NUCLEAR REGULATORY COMMISSION

Title: Advisory Committee on Reactor Safeguards
 Plant License Renewal Subcommittee
 Prairie Island Nuclear Generating Station

Date: Tuesday, July 7, 2009

Containment Vessel

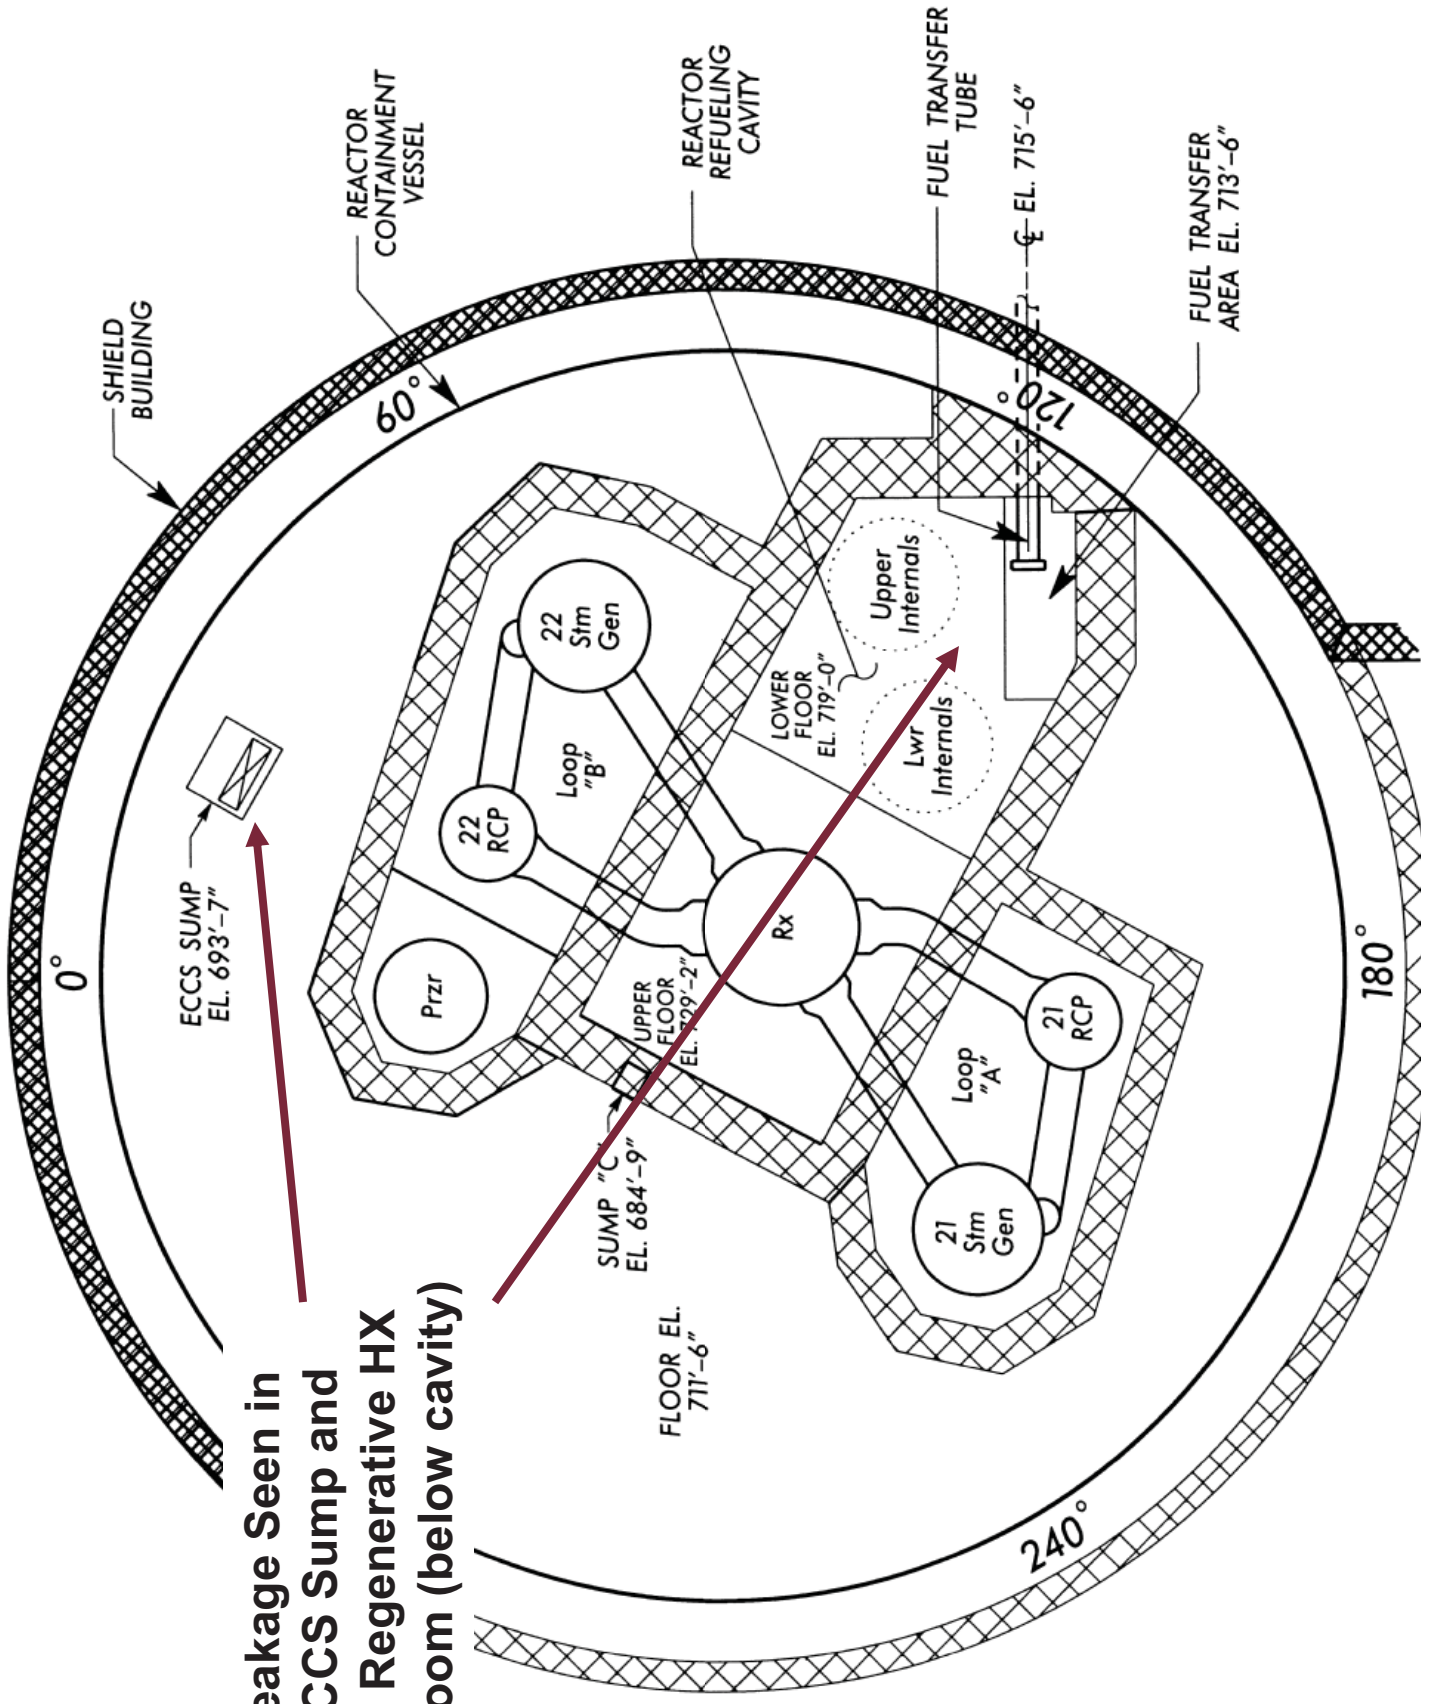
19 Actually, if you turn to the last slide
20 in your presentation -- we did include a figure so we
21 can look at that. The containment pressure vessel
22 itself has an inch and a half thick bottom head, an
23 inch and a half thick shell, and the top head is 3/4
24 of an inch thick.

5 The lower head, as you can see in the
6 drawing, is fully encased in concrete on both sides.
7 The remainder of the containment pressure vessel --
8 and there's a five foot annular gap between the
9 containment vessel itself and the one in the leakage
10 -- reinforce the concrete shield building. That
11 allows us access to the vast majority of the
12 containment pressure vessel itself.

Refueling Cavity Leakage Leak Locations

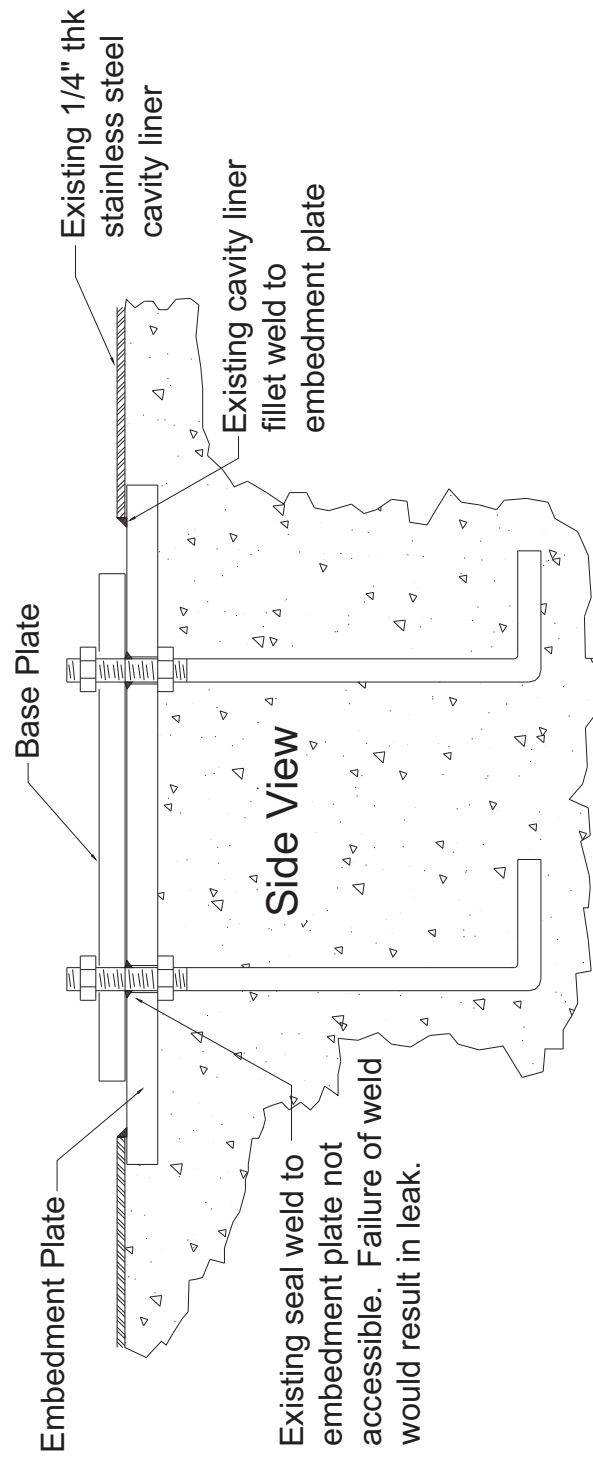
21 The actual leak locations themselves, the
22 typical reactor vessel internals support stand is in
23 the left and the typical RCC change fixture support
24 stand is on the right. There are eight internal
25 support stands and we have three NRCC change fixture

2 The leakage, we believe to be flowing the
3 threads down past the nut. Once past the nut, there's
4 a seal weld -- this is the RCC change fixture -- seal
5 weld that was installed when this was originally put
6 in.

17 MR. SKOYEN: Yes. Past actions that we've
18 taken, most recently was caulking and we would remove
19 the nuts from the top of the base plate, underneath
20 those nuts to prevent the leakage from going past the
21 threads. Then between the base plate and the
22 embedment plate, we would try to caulk there.

3 MR. SKOYEN: All right. We plan to prepare
4 to permanently eliminate the leakage during our next
5 refueling outage on each unit.

1 permanently eliminate the leakage that occurs from
2 both the internal stands and the RCC change fixture
3 support stands.

Refueling Cavity Leakage Inspection Results to Date

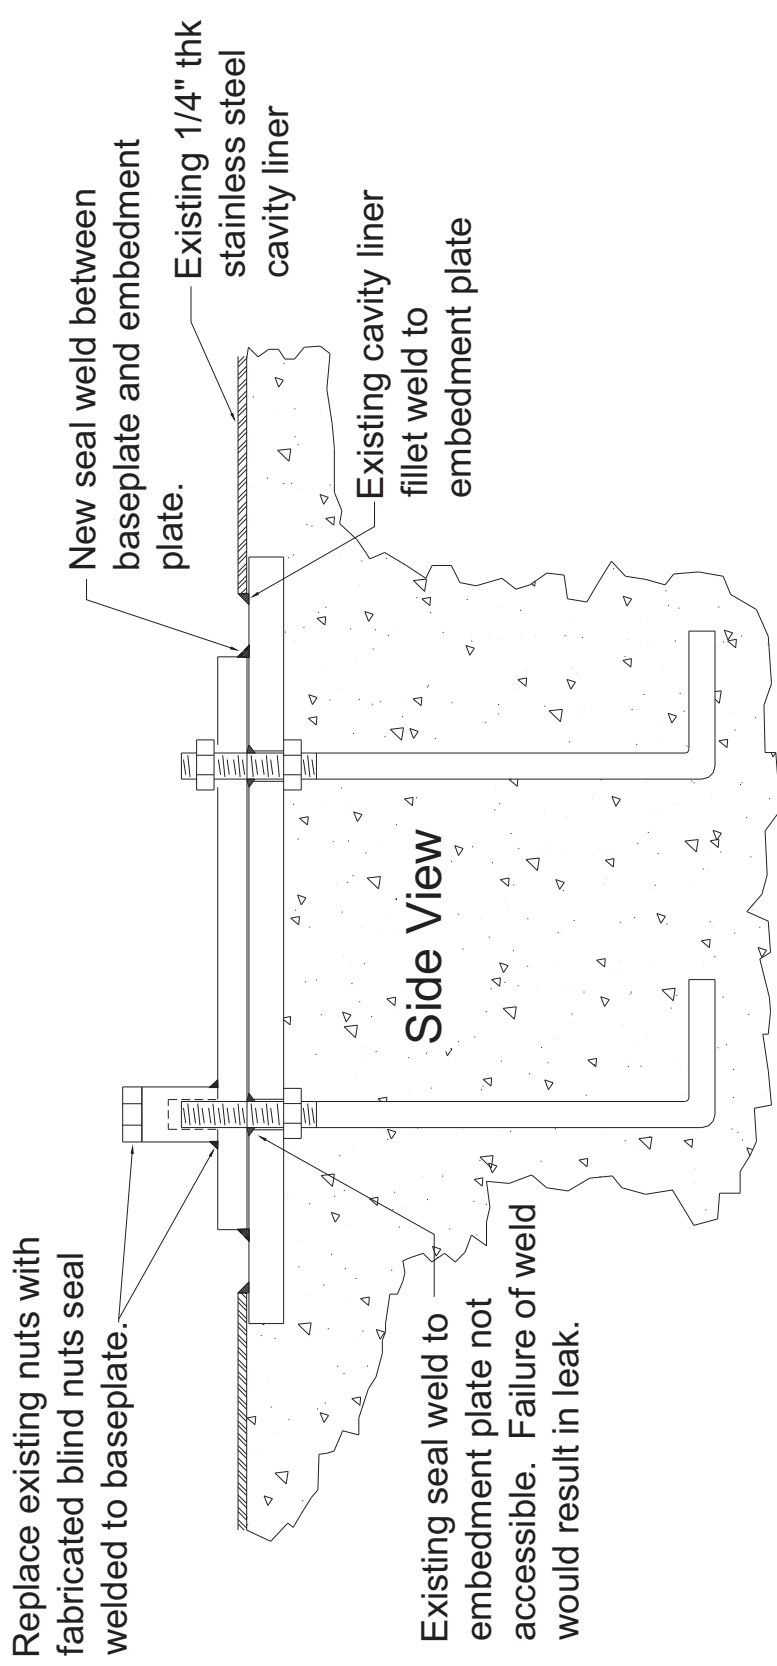
18 MR. SKOYEN: Correct. Regarding
19 inspections that we've done related to the leakage,
20 we have poured ultrasonic examinations and visual
21 examinations of the containment vessel.

9 Again, that's 16 to 18 inches of concrete
10 we'll have to remove. Once that's removed, we'll be
11 performing both a visual examination and an
12 ultrasonic examination to assess the containment
13 pressure vessel.

7 We'll continue general monitoring for new
8 leakage using the structures monitoring program per
9 ASME section 11 IWE program for the remainder of the
10 plant life.
